**WORCESTER TOWNSHIP PLANNING COMMISSION MEETING**  
**WORCESTER TOWNSHIP COMMUNITY HALL**  
**1031 VALLEY FORGE ROAD, WORCESTER, PA 19490**  
**THURSDAY, FEBRUARY 22, 2018, 7:30 PM**

March 12, 2018  
Ref: #7484

Reference: Center Square Golf Club – Subdivision Plan  
Skippack Pike, Whitehall Road & Berks Road  
Revised Plan Review

Exhibit "B"

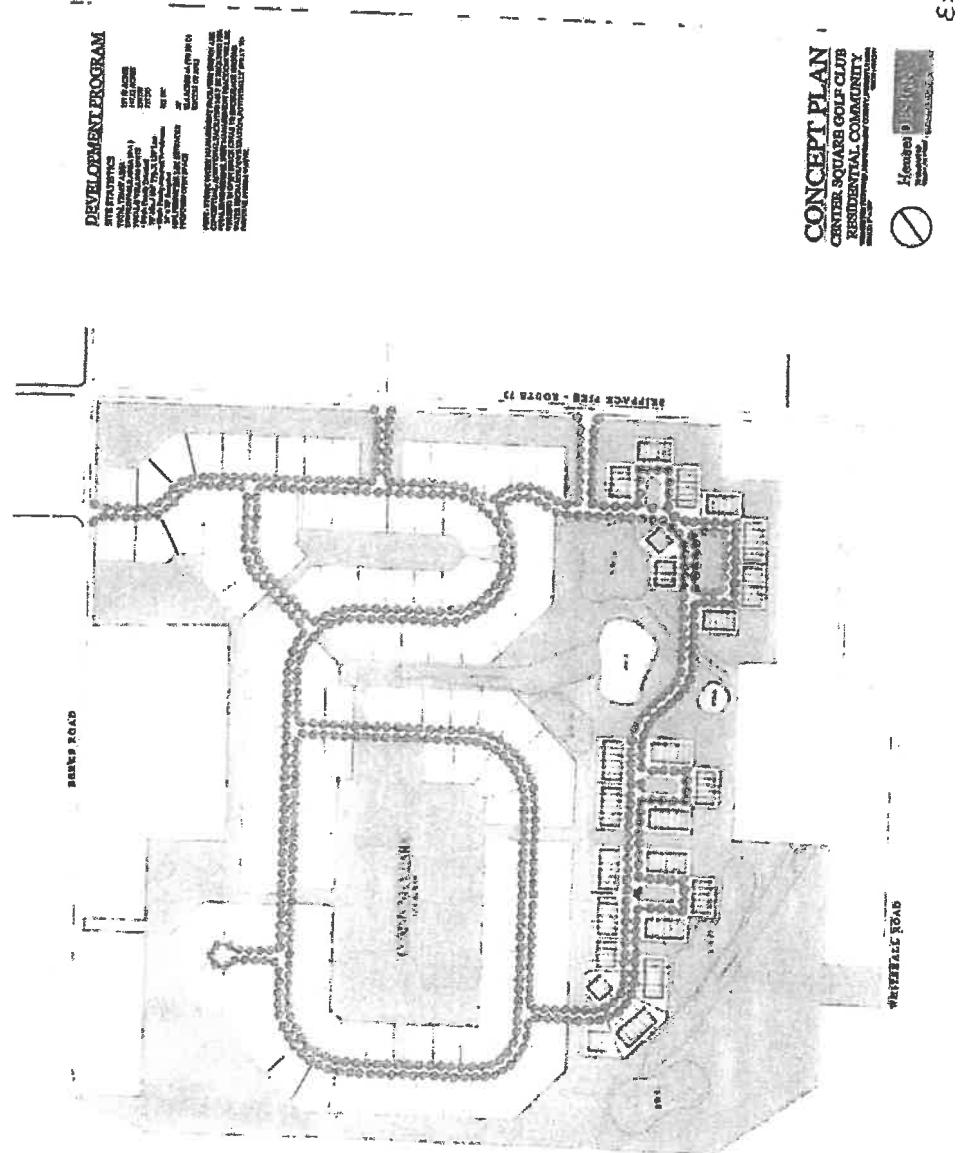
- B. We recommend that trails be distributed throughout the open space located on the site, particularly in the Open Space Parcel D (central open space area) with a connection to Open Space Parcel F. SFD units 101 and 102 could potentially be shifted to allow for a connection between Open Space Parcel D and Open Space Parcel F. Trail connections to the power line area just south of the site is also recommended as it is included in the Township's Open Space Plan as a future trail connection.
